Outline – 21May04 Conference Call

Proposed Model for Simulation from 22April04

Proposed Model for Simulation ... NO Changes ... But ???

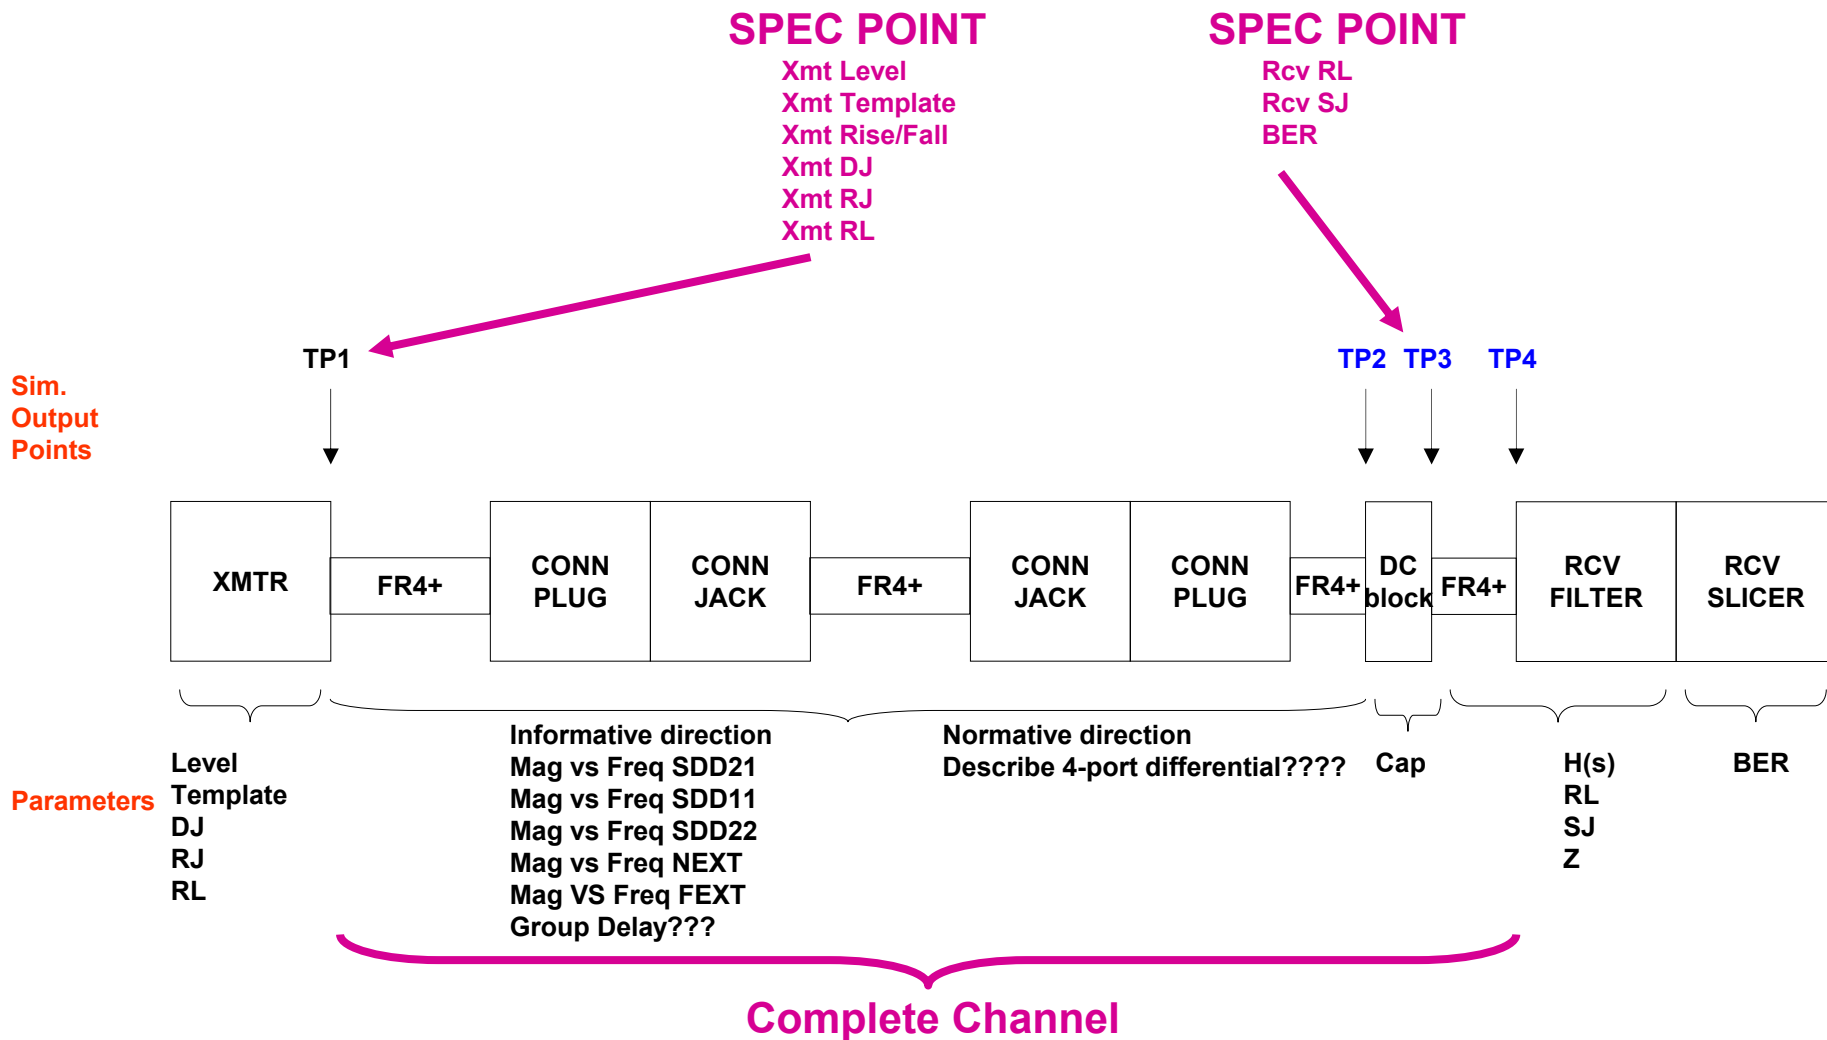
- Measuring Return Loss at the package might be an issue.
- Measuring channels without reference to DC blocking might impede early coding evaluation.
- Not fair to assume the DC block should reside in the chip at this stage of development.
- Action Item ... when we get to RL, I would like to discuss an informative means to measure this. Perhaps we can devote a call to it
